In the beginning there was version 1 of the schematic.

From this a PCB was made which is marked 2686420A\_y22

### PCB corrections required to 26866420A\_Y22

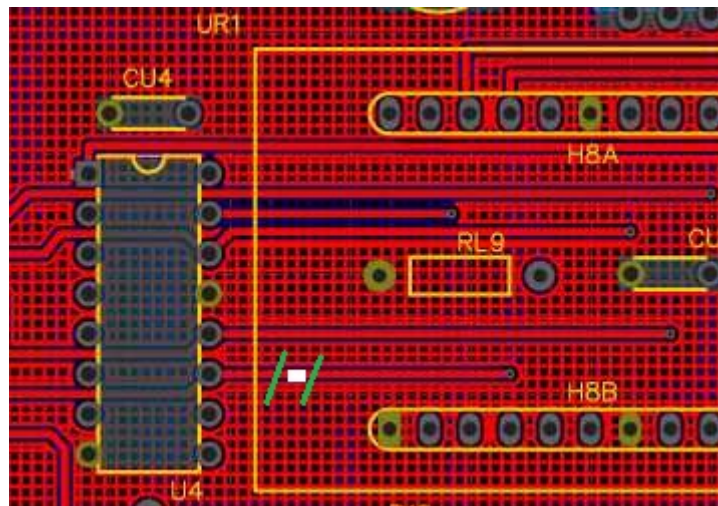
Version 2 of the schematic<sup>1</sup> contains:

- Two PCB corrections; and
- Adds VCC to H5A and text on how to connect an optical encoder instead of the assumed mechanical encoder.

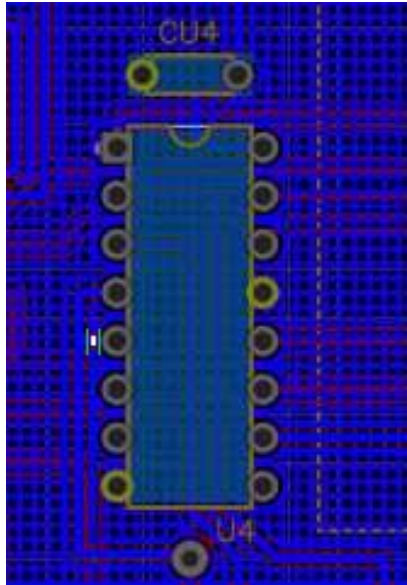
Two tracks need to be cut.

On the top (component) layer of the PCB cut the track running from U4 pin to 17 on H8A as shown below.

On the bottom layer of the PCB cut the track running from U4 pin 5 to U4 pin 4 as shown below.
